Effluent Limitations Guidelines and Standards for the Steam Electric Power Generating Point Source Category: EPA's Response to Public Comments

Part 5 of 10

7. Industry Operations

Chart 1: ORP versus exhaust gas flow

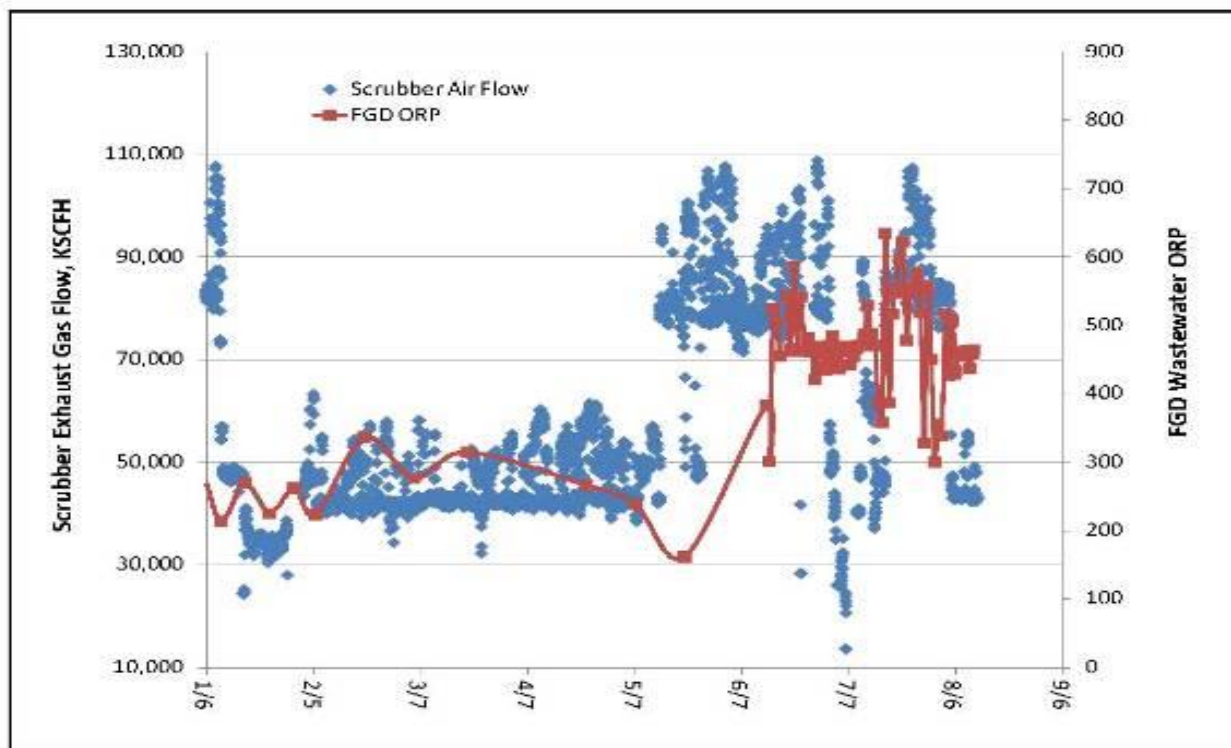
FGD wastewater. Chart 1 shows that higher exhaust gas flows cause the FGD wastewater to have a higher ORP. Thus, the FGD wastewater quality characteristics will change as a function of the number of generating units in service. It is not clear that the EPA's use of data from only two FGD wastewater biological treatment systems has taken this variability into account. We urge the EPA to step back and consider data from a broader set of FGD wastewater systems, using a variety of coals, multiple operating conditions and other variables, when developing a new ELG.

The ORP of the scrubber solution will impact the pH as well as the selenium, nitrate, and arsenic concentrations of FGD wastewater.

Chart 2: Wastewater pH and ORP variability over time

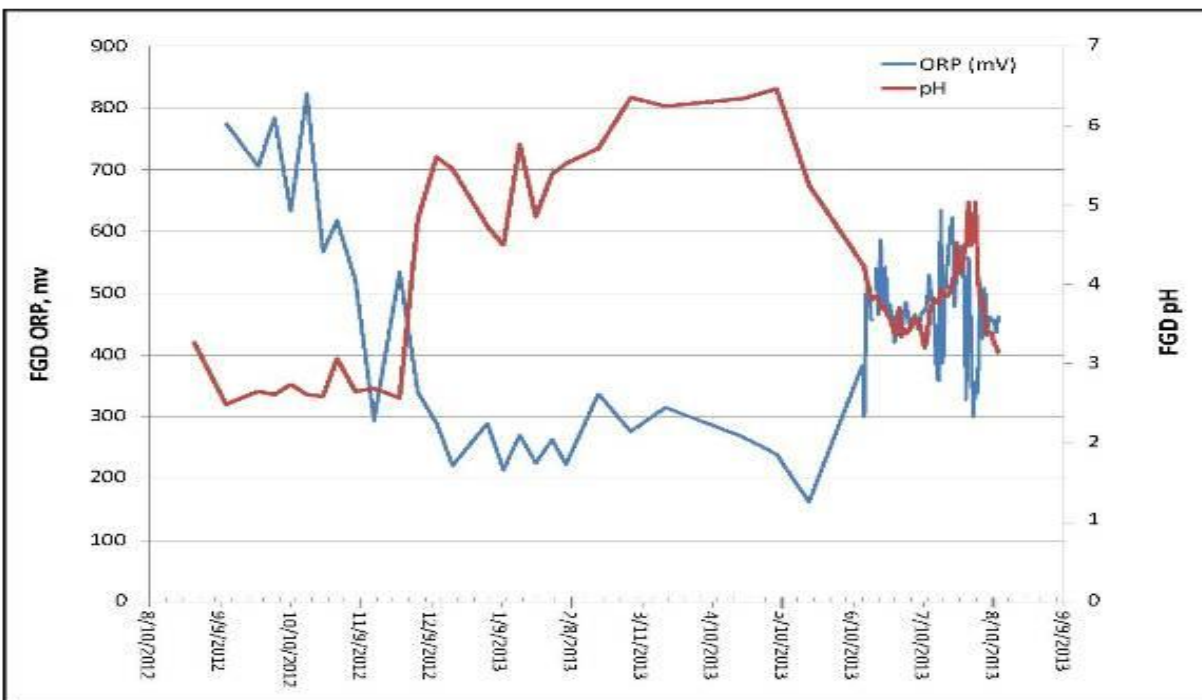
FGD wastewater has essentially no alkalinity; therefore, even small amounts of hypochlorous acid generated can quickly lower the pH of the FGD wastewater. Presented in Chart 2 is a graph showing the variation in FGD wastewater pH and ORP over time.

The variability in ORP and pH can also make it difficult to remove nitrates from FGD wastewater, a necessary step prior to treatment for selenium removal.

Chart 3: FGD wastewater nitrate variation over time

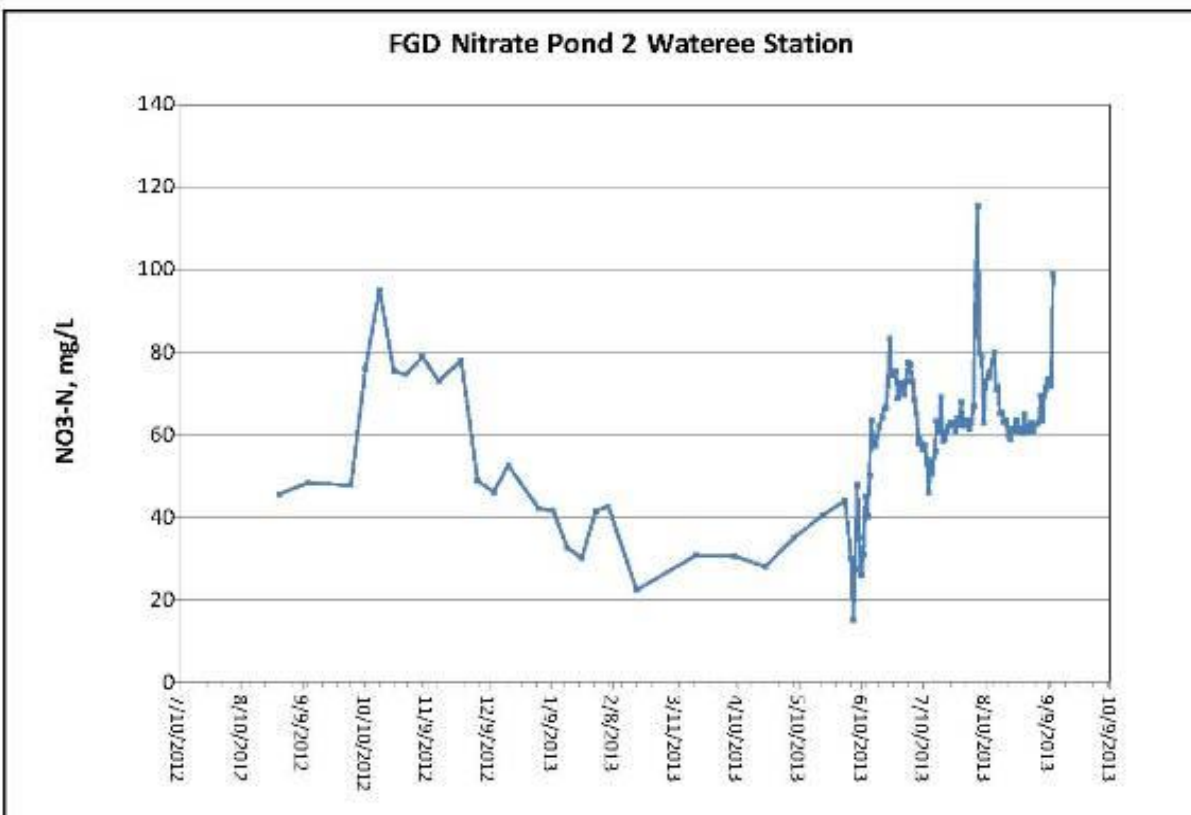
Nitrate concentrations can vary in the FGD wastewater due to changes in the operation of the selective catalytic reduction (SCR) process over time. Increased ammonia slip caused by SCR aging, or simple adjustments in ammonia feed can cause significant changes to the nitrate concentrations in the FGD wastewater. SCE&G recommends that the EPA remove nitrate/nitrite limits from the proposed ELG Rule. Total nitrogen should be addressed as a nutrient issue with NPDES limits, not in the ELG Rule.

Chart 4: Selenium concentrations in the Wateree FGD wastewater

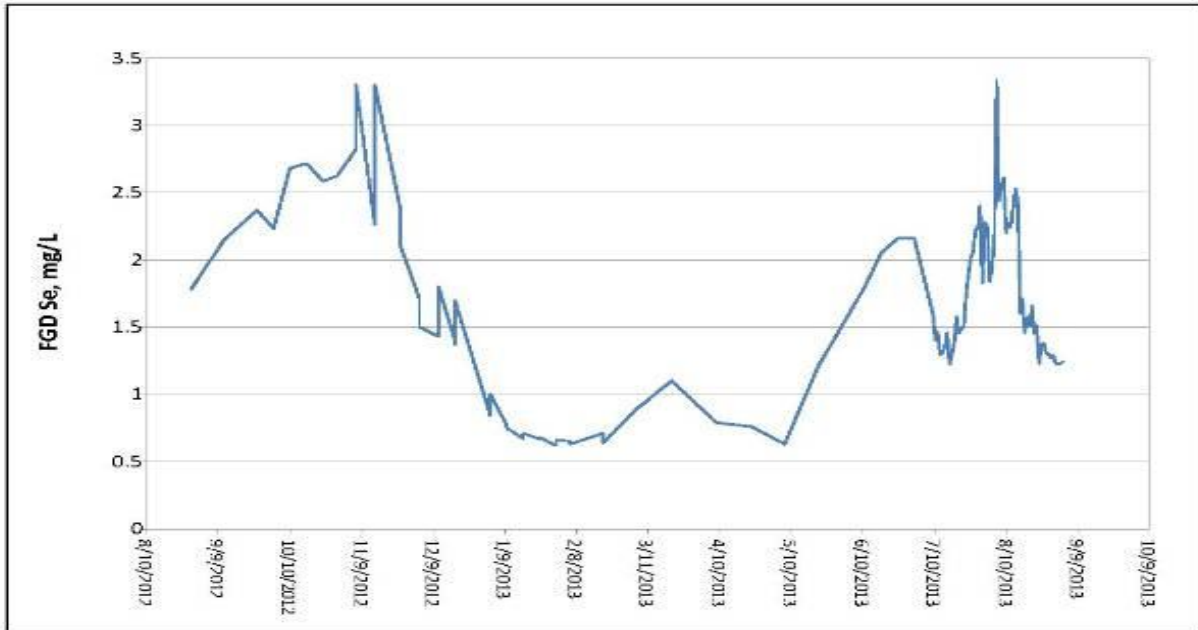
Selenium concentration changes in the FGD wastewater will impact the ability of biological treatment systems to meet the very low proposed ELG limits. We also note that selenium concentrations can change fairly rapidly, resulting in the requirement of the bacteria to quickly respond to the changes. This variability in selenium will make it difficult to meet the very low proposed ELG limits.

Chart 5: Nitrate and selenium concentrations in FGD wastewater over time

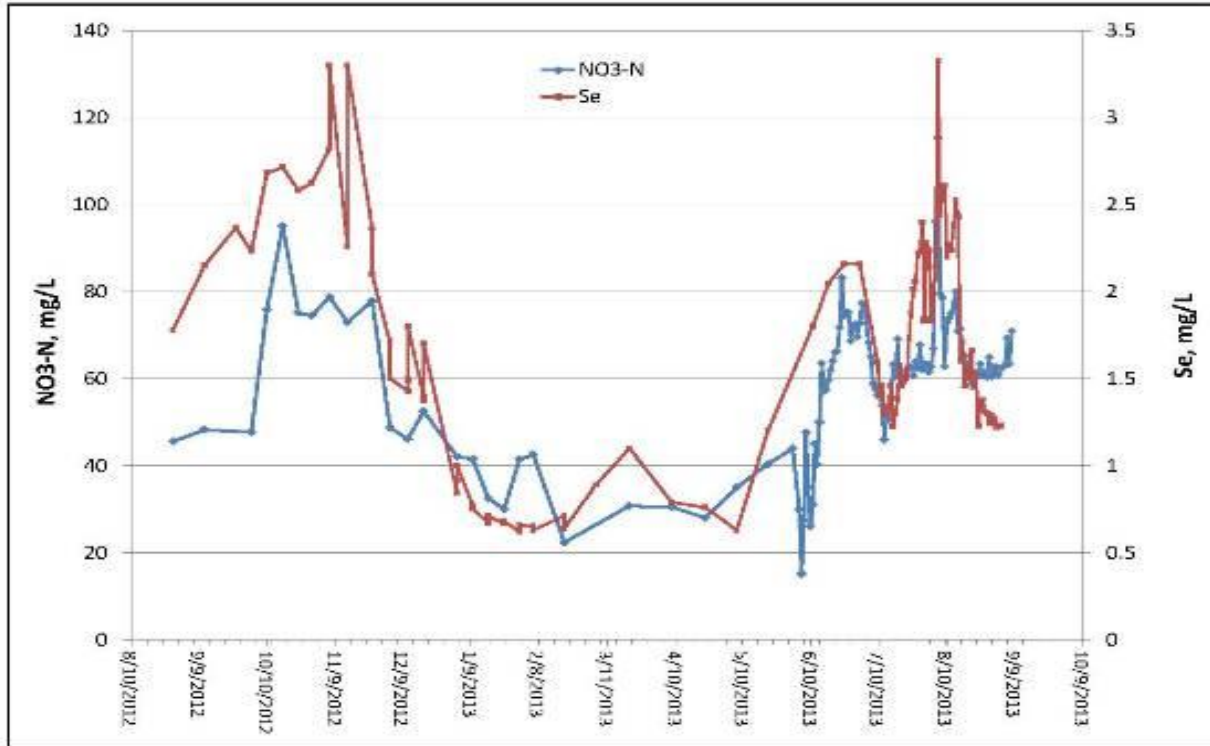
Based on data collected at Wateree Station, nitrate and selenium concentrations seem to vary in concert. The concurrent changes in selenium and nitrate concentrations could significantly hamper the biological treatment processes, since the same organisms that remove selenium from wastewater must first react and remove nitrates. Presented in Chart 5 are the nitrate and selenium concentrations in FGD wastewater over time. Due to the limited data set which the EPA used to characterize FGD wastewater, it is not possible to adequately address the fluctuations in the FGD wastewater that occur during normal operation of a power plant.

Chart 6: Mercury concentration in the FGD wastewater over time

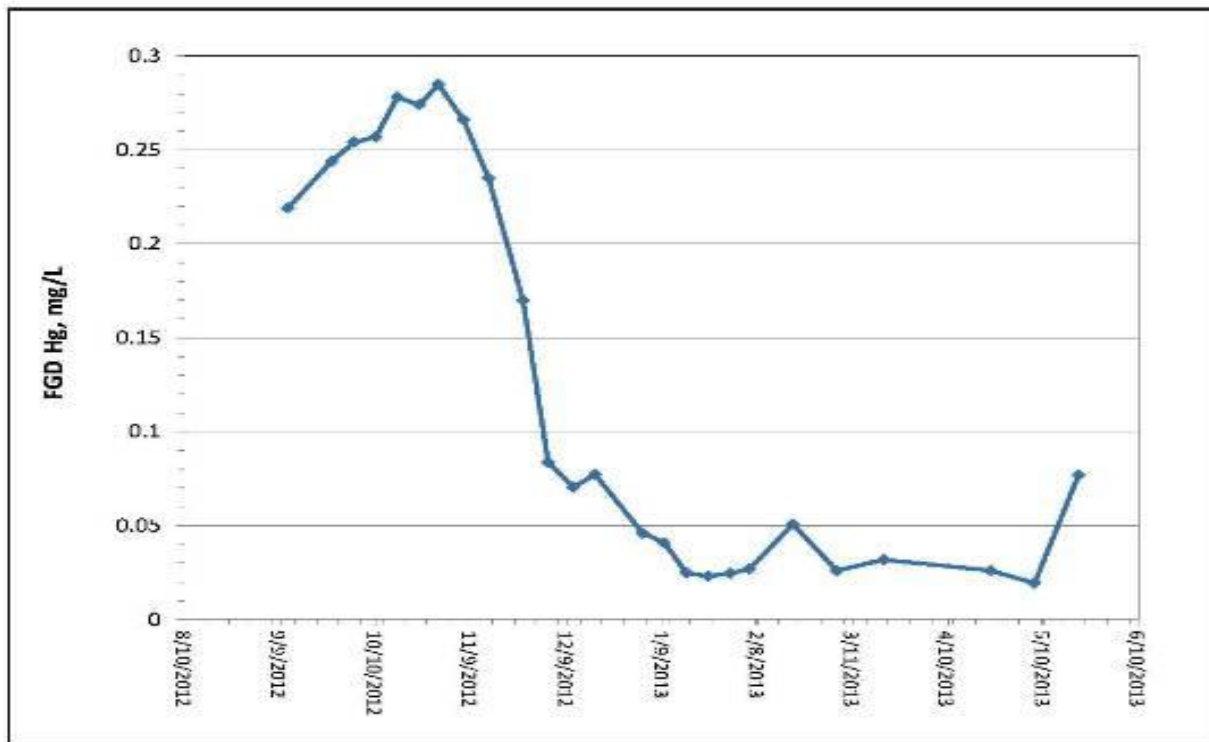
The concentration of mercury in the FGD wastewater also changes over time. Mercury, selenium, and nitrate concentrations in FGD wastewater all appear to be influenced by the ORP and the number of generating units in service. Chart 6 presents the mercury concentrations in the FGD wastewater over time. These variations in mercury concentration will impact the treatment processes and result in possible treatment inefficiencies and ELG limit excursions.

Figure 4-1
Comparison of EPRI and EPA Average Constituent Concentrations for FGD Wastewater Streams

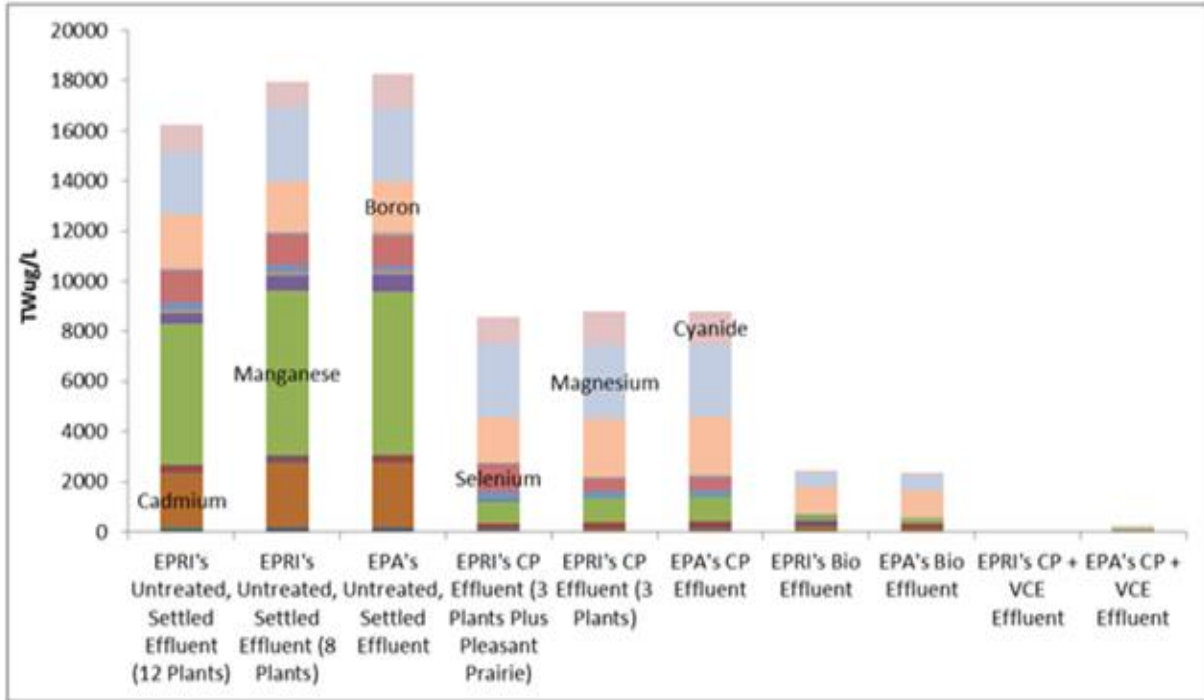
EPA did not include the effluent data from the four plants they sampled in 2007 because different analytical methods were used at these sites; however, the influent settled data should be acceptable for inclusion. Regardless, the addition of these four sites had little effect on the overall average concentrations of FGD wastewater constituents, as shown in Figure 4-1.

EPRI included the Pleasant Prairie data in its calculation of average constituent concentrations for CP effluent because FGD wastewater treatment at the plant meets the definition of BAT. The addition of the Pleasant Prairie data had very little effect on the average constituent concentrations, as shown in Figure 4-1.

Figure 4-2
 Comparison of EPA Average Water Quality Characteristics and EPRI Water Quality Characteristics
 Derived Using Coal Rank for FGD Wastewater Streams (top and bottom)

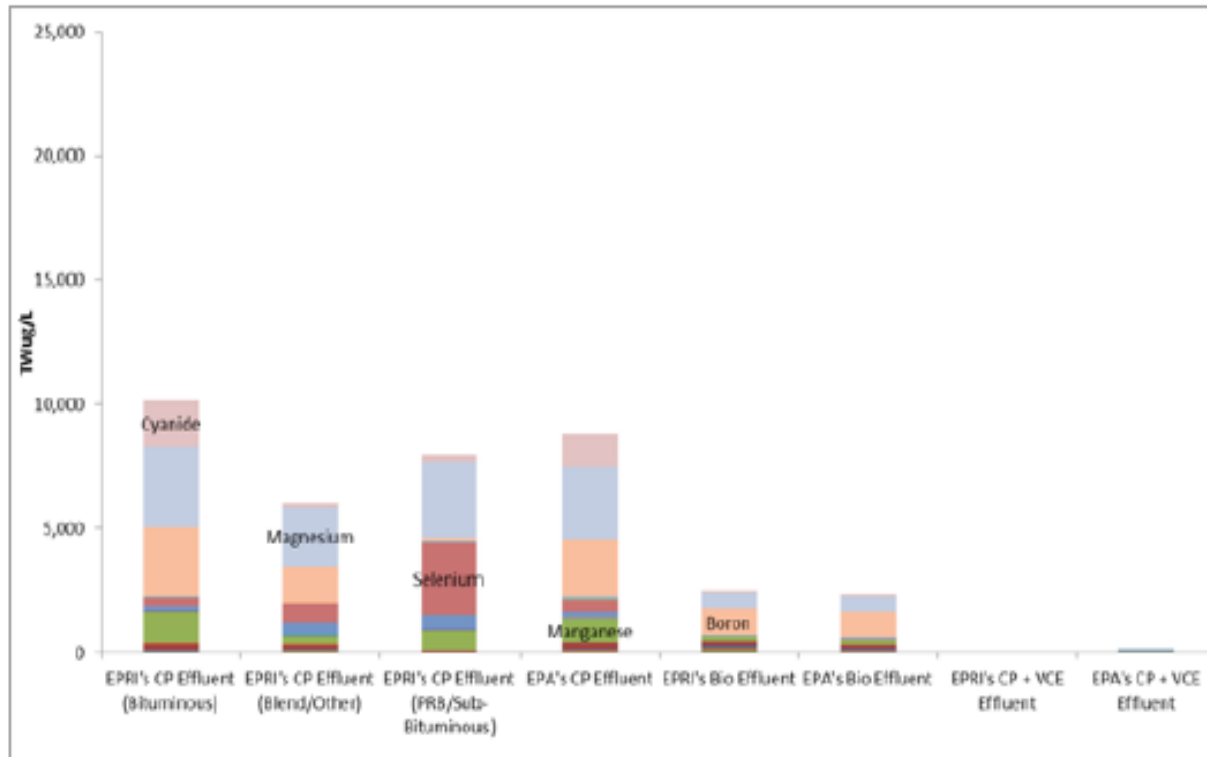
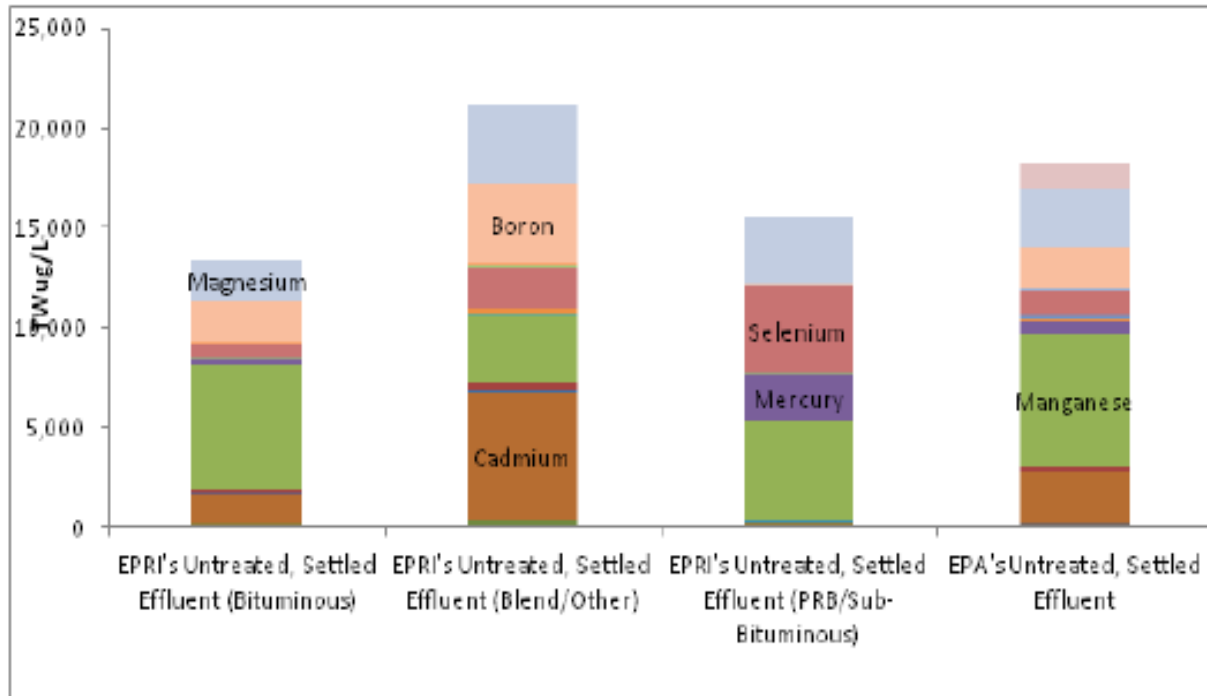
Figure 4-2 shows water quality estimates for each constituent used by EPRI and EPA in pollutant removal calculations. When EPRI's water quality estimate is weighted, using the percent of the industry's FGD wastewater flow by each coal type, the difference between water quality estimates by EPRI and EPA is small—less than 10 percent.
